**Epic Mining Pty Limited  
Luddenham Clay/Shale Quarry  
Modification 4 of Development Consent DA315-7-2003  
Addendum to Response to Submissions – October 2017**

**Luddenham Clay/Shale Quarry- Modification 4 (DA 315-7-2003 MOD 4)**  
**Request for Revised Response to Submissions**

**B4 Revised Proposed Site Layout including accurate Location of the Riparian Zone and the Aboriginal Exclusion Area - A4**

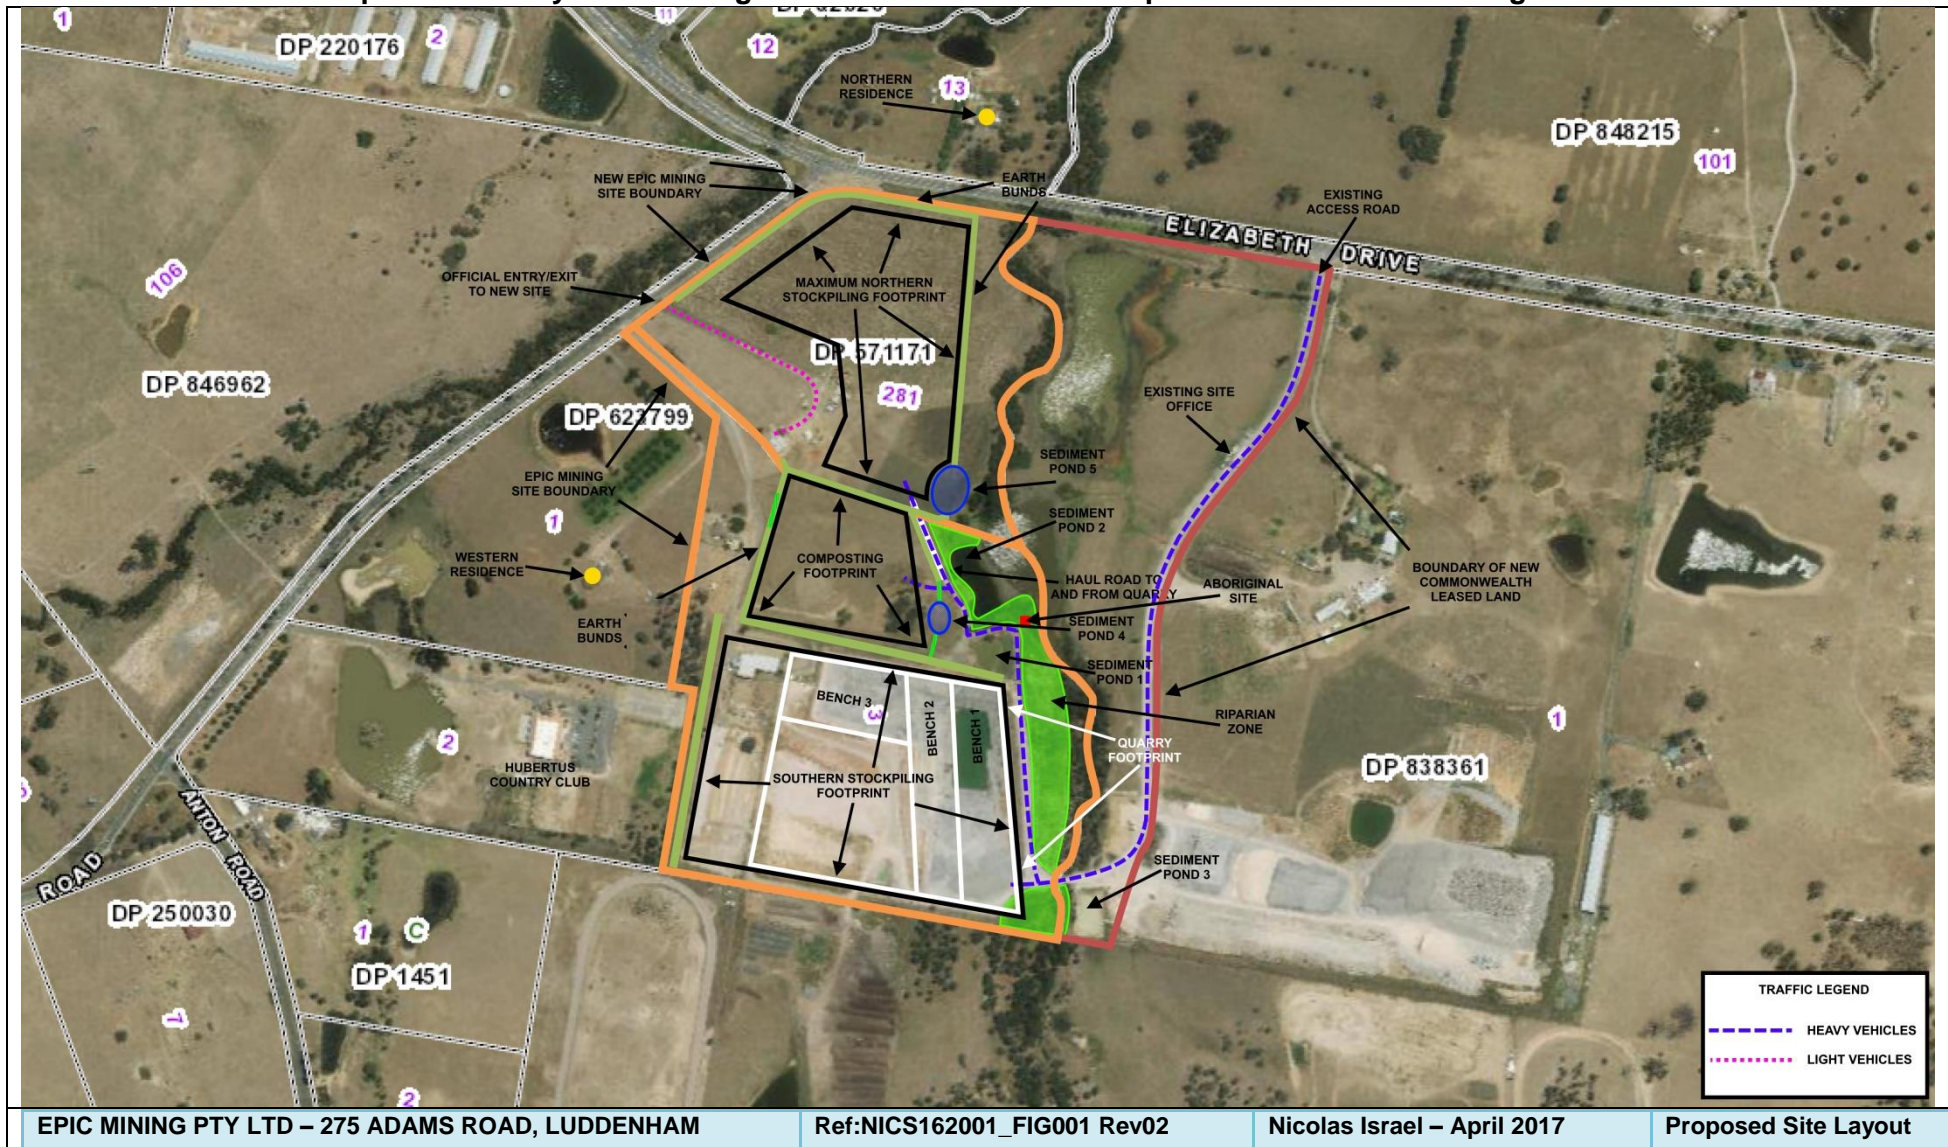
*Building on the advice from DPI, please provide an updated proposed site layout that shows the 40 metre riparian exclusion zone and the Aboriginal exclusion area. Please also differentiate between the main access road off Elizabeth Drive and the light vehicle employee driveway off Adams Road.*

Due to the so many items and aspects to be included in the proposed site layout, it will be very confusing if all these aspects/structures/activities are included in one plan only. The requested information was previously included in different plans since they served different purposes and were part of different assessments. The light and heavy vehicle routes were including in **Appendix K** of the EA as drawing No **NICS162001\_FIG004 Rev01** (Attached ). Attached are also the previously submitted plans which included the requested information. **Attached is also a revised site layout that includes all requested information associated with the Riparian Zone and the Aboriginal exclusion area.**
